| Final Sign off of EPC Site Plan | | | |

Per the official notice of decision dated July 15, 2021 for Major Amendment to a Site Plan-EPC please find the following responses addressing the conditions of approval for project #2021-005301/SI-2021-00452 for a submittal action to DRB for Final-sign off for Site Development Plan- EPC:

| | NM 528 AND ELLISON 3615 HWY 528 SITE PLAN - EPC | DRAWN BY LN DATE 08/02/2021 DRAWING 2014069-SPE |

Sheet Number:
LS-01

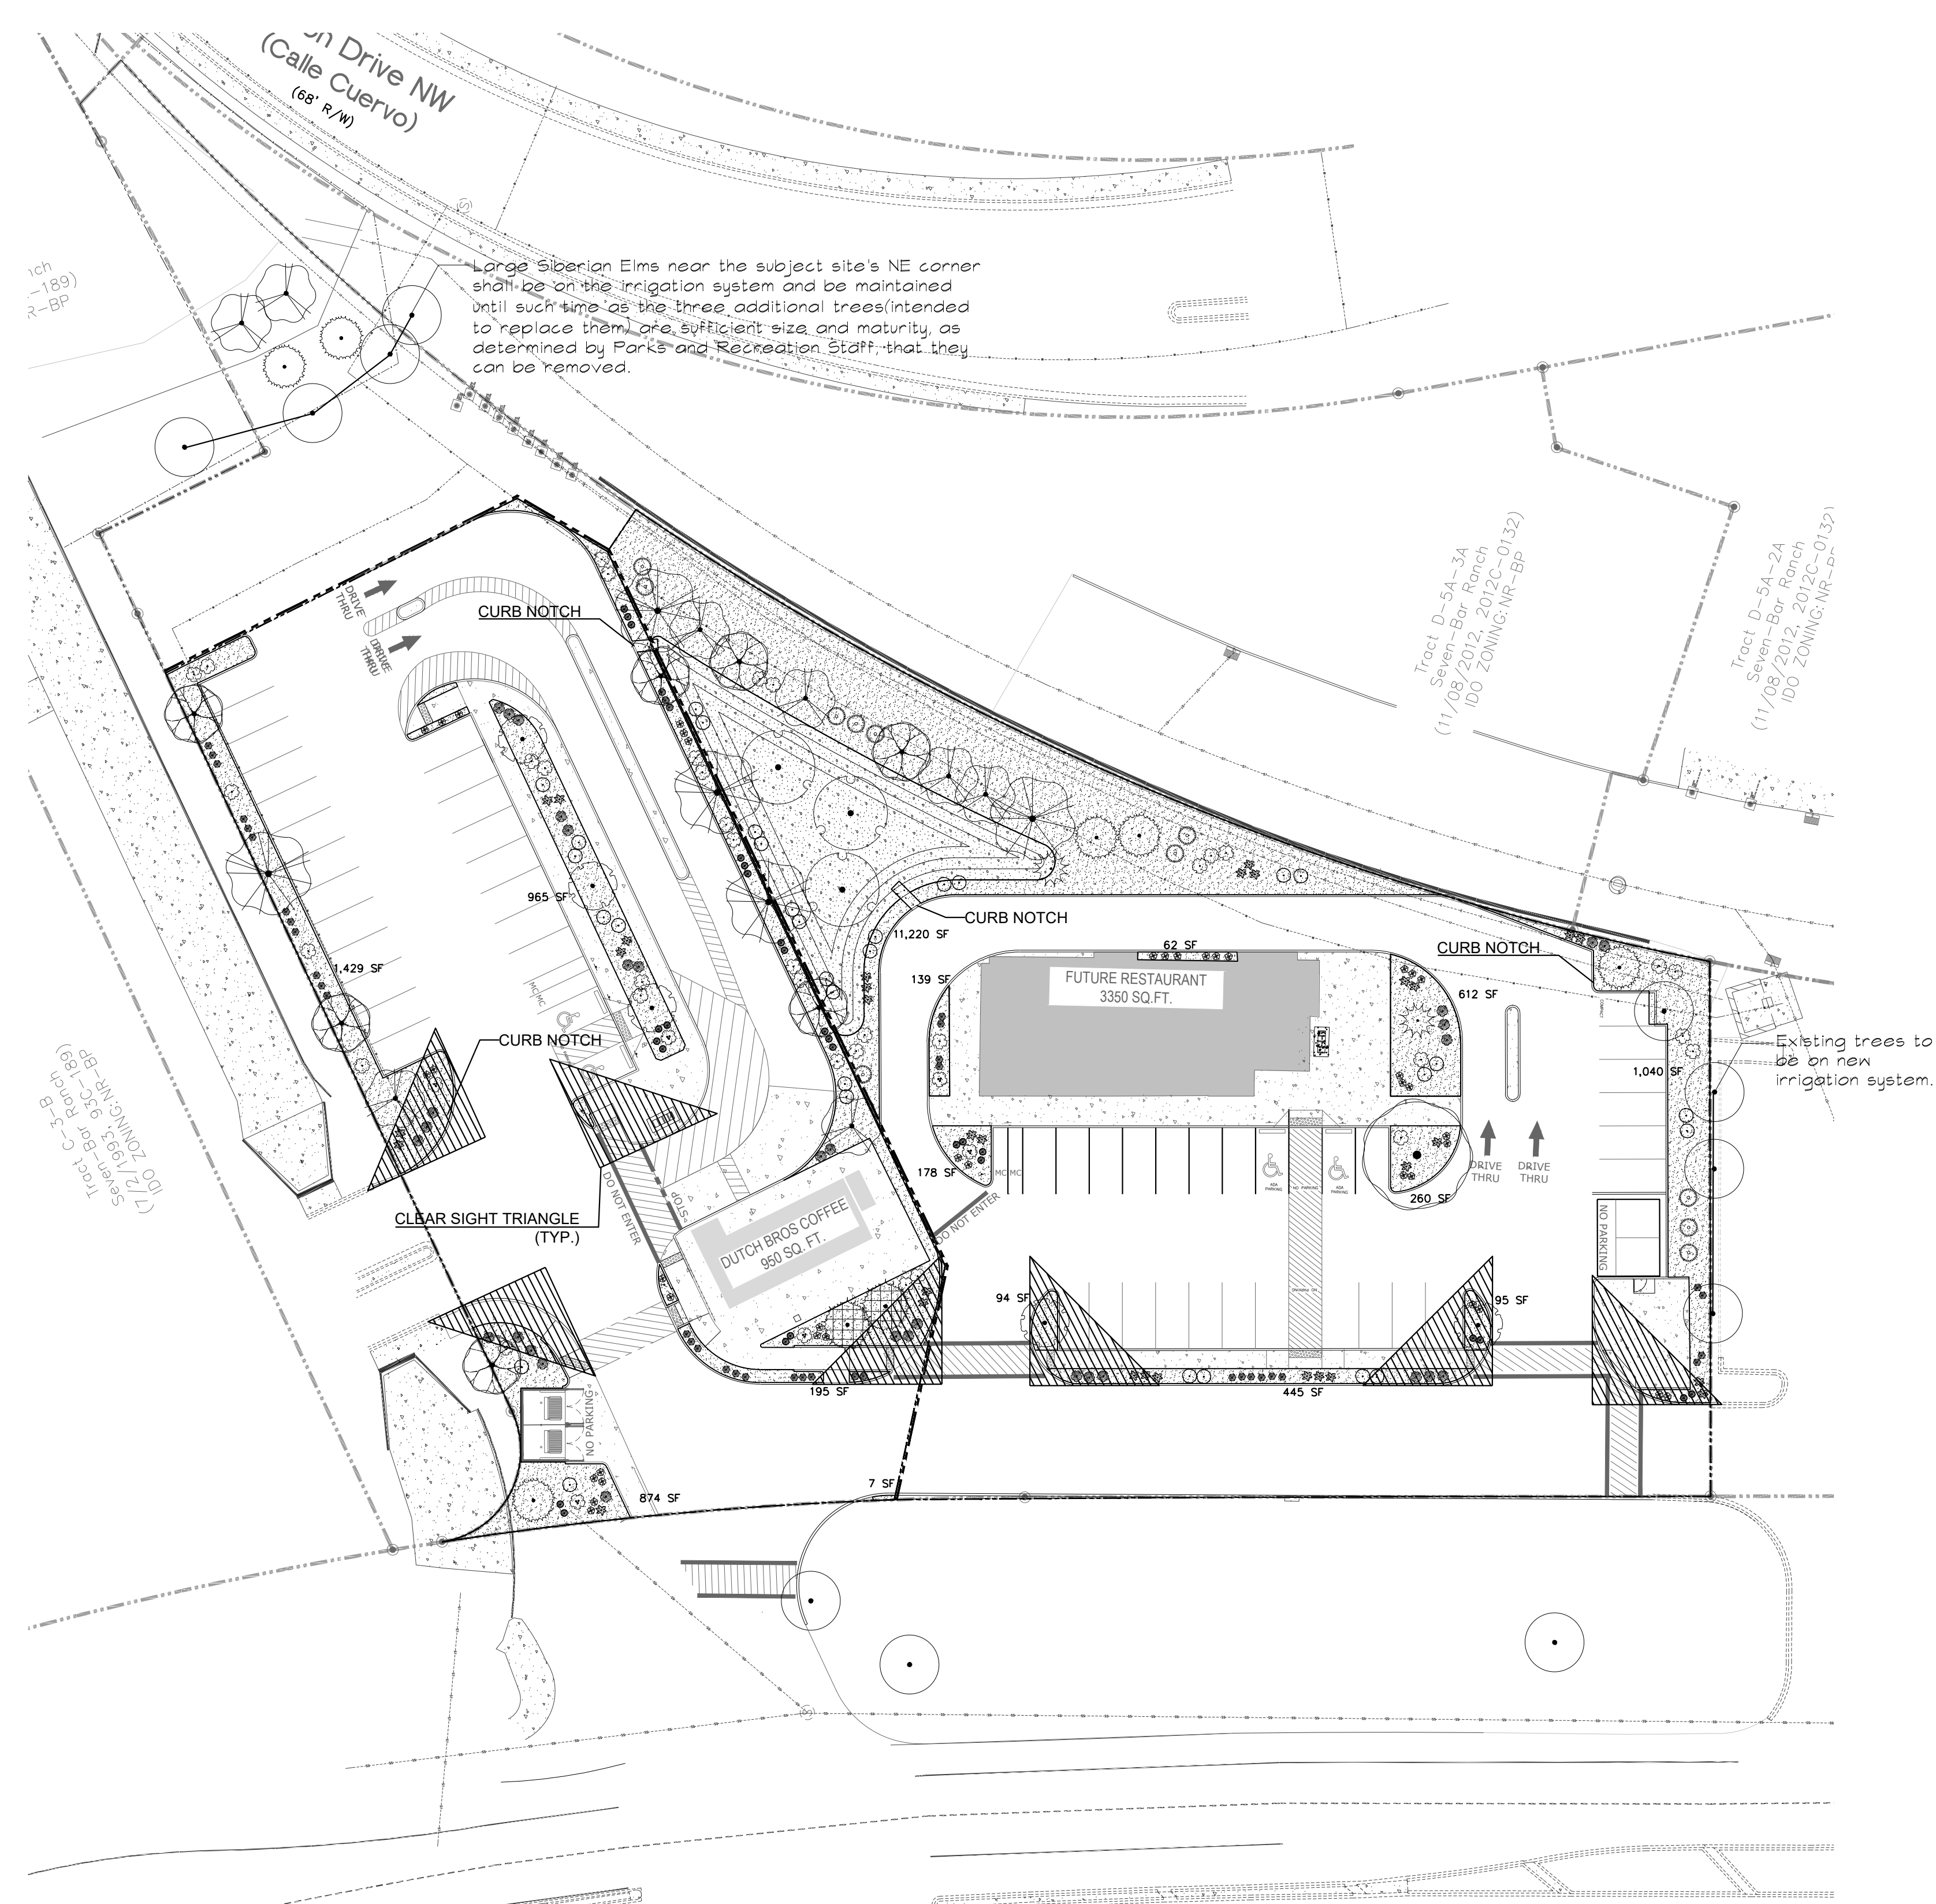
- a. Two Pinon Pine Trees shall be added to the triangular shaped area of the subject site that extends to the northeast.

- c. The total coverage figure shall match the figure used in the landscaping calculations.

Response: Two Pinon trees were added to the northeast area. See landscaping plan LS-01.

Response: Acknowledged, see landscaping plan sheet LS-01 for updated location.

Response: Acknowledged, see landscaping plan sheet LS-01.
